**465 – 467 Finchley Road
London NW3 6HS**

**Basement Impact Assessment
Audit**

London Borough of Camden

Project Number: 12066-56
Revision: F1

ABSTRACT
AB1115_SK/F/01

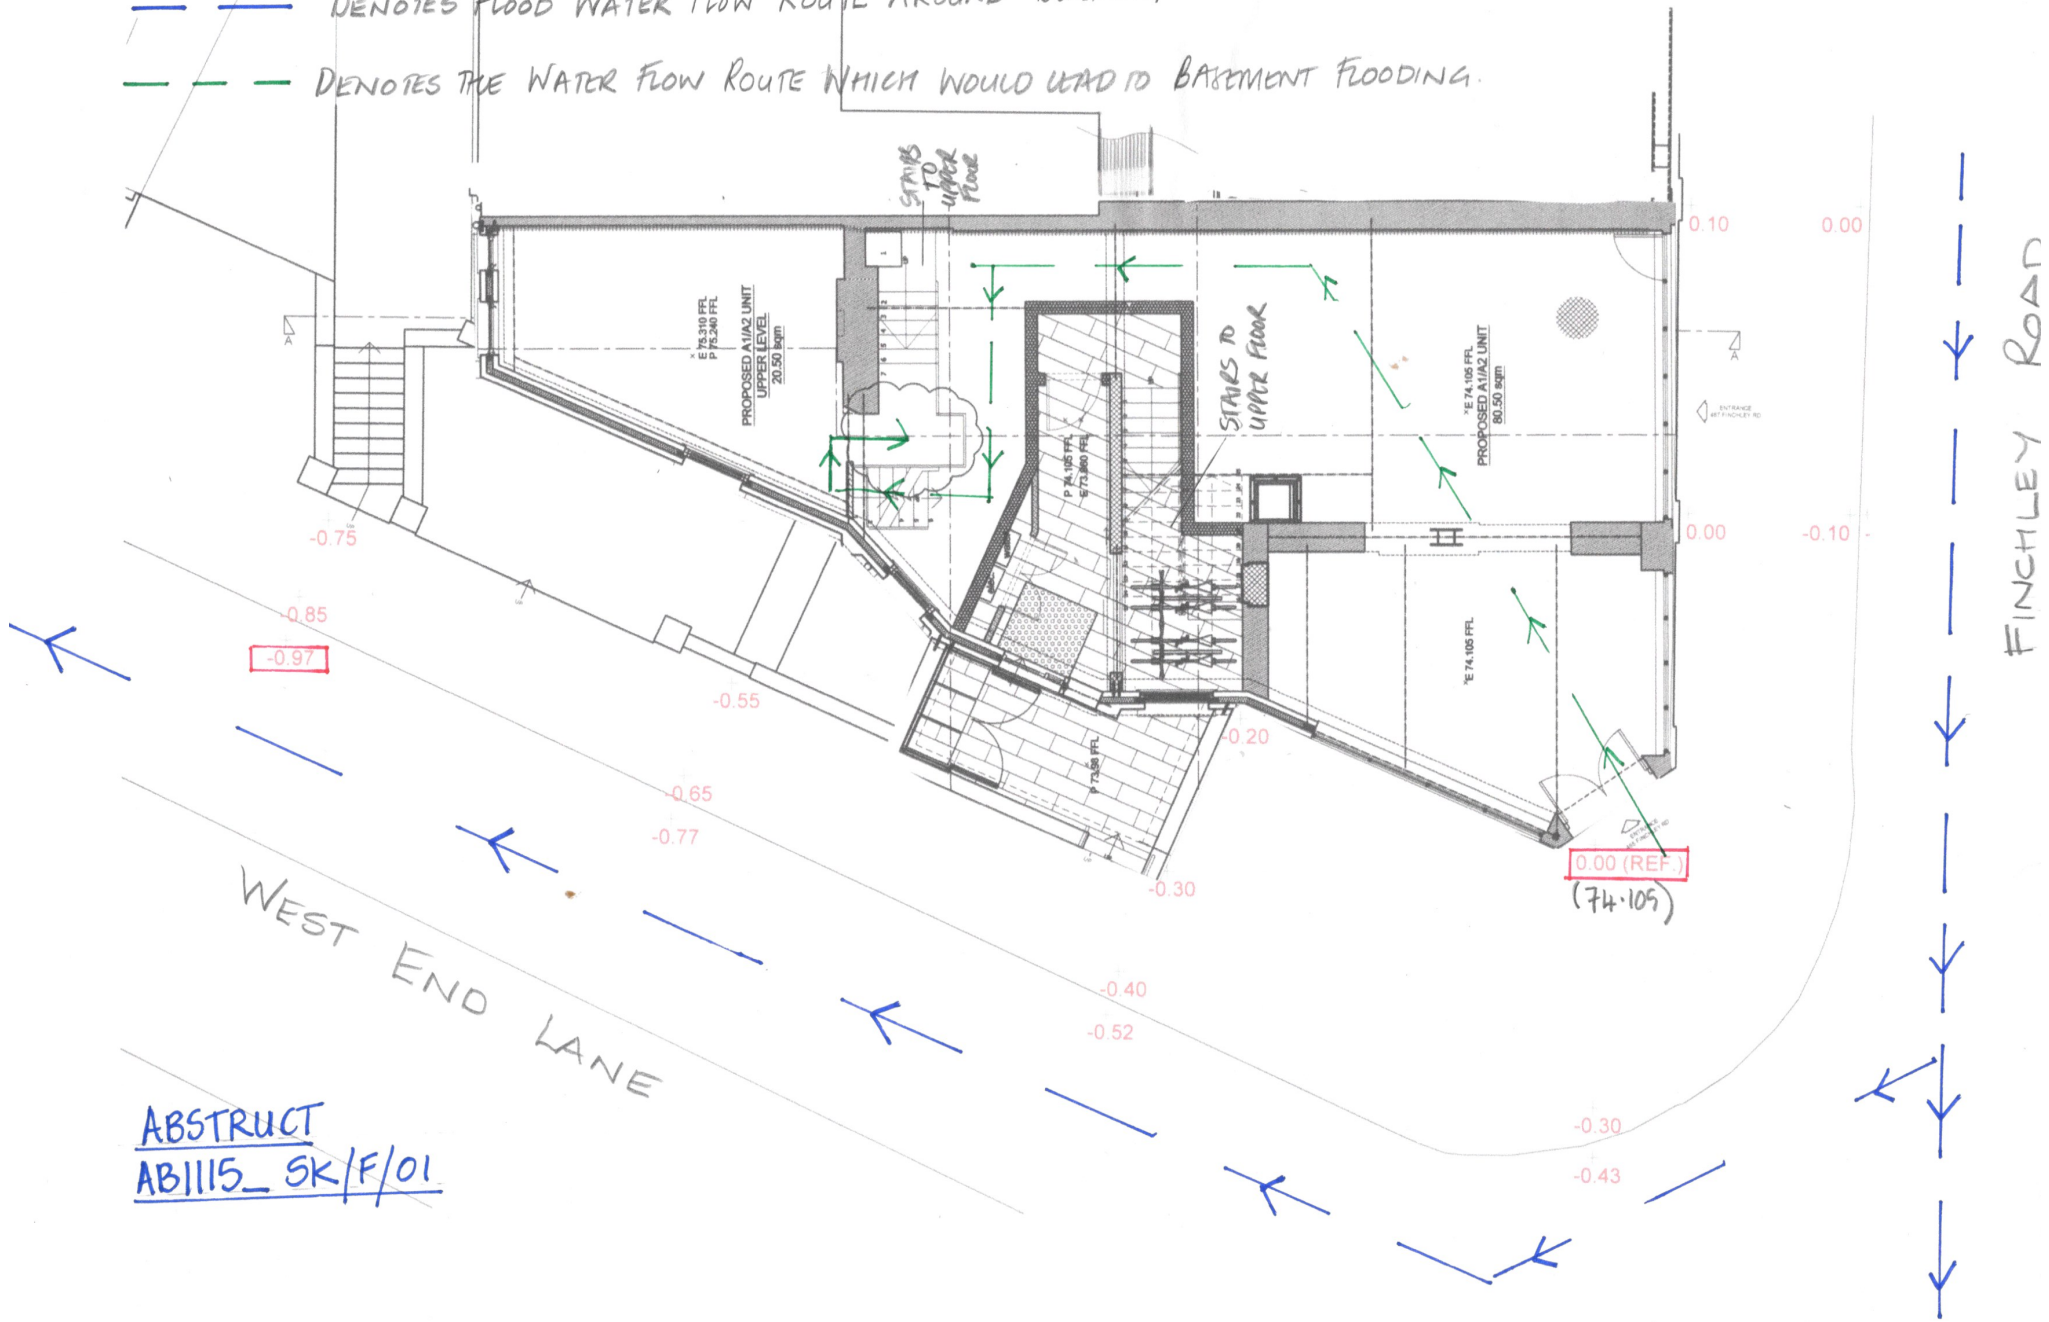
- 4.5. Finchley Road and West End Lane were both flooded in the 2002 flood event. It is stated in the BIA that the risk of surface water flooding is unlikely and topographical information indicating surface water as a result of flooding is likely to move away from the site down West End Lane and Finchley Road is presented. Abstract have further stated in an email on 17 December 2015 that flood mitigation measures are not required as part of the proposed works because the site levels, pavement and road levels together with the proposed layout do not provide a viable route for flood water to penetrate the new basement. A sketch (AB1115_SK/F/01) denoting the anticipated flood water route around the building has been included in Appendix 3.

Email response from Abstruct (17/12/15) on surface water flood risk query
Abstruct sketch (AB1115_SK/F/01) showing anticipated flood water flow route

Additional flood mitigation measures are not required as part of the proposed works, as the site levels, external pavement and road levels and proposed layout do not provide a viable route for external surface flood water to be able to penetrate the new basement area.

Please see the attached sketch mark-up plan AB1115_SK/F/01 for reference.

The external ground levels fall away from the building - West End Lane falls away from the site and downhill towards the west, Finchley Road falls away to the south. From the front (south-east) corner of the building (taken as datum 0.00) West End Lane falls rapidly in level by almost 1.0m reaching the most western end of the building.

There are only two entrances to the building.

The first is the main entrance on the corner of West End Lane and Finchley Road. The existing pavement/road levels here run downhill away from this entrance. A very significant flood event would need to occur before any water might penetrate into the building at ground floor level at this location. Should this occur, any water which entered the building at this location would then need to take a convoluted route towards the back of the building, involving a stair down to the existing rear sub-basement before water can penetrate the new basement area.

The second entrance to the building is on the south elevation along West End lane. This entrance is set at a higher level to the external pavement and road levels and only provides access to the upper floors of the building (not the basement). It is therefore highly unlikely that water can ingress the building here and if it does, it cannot access the basement.
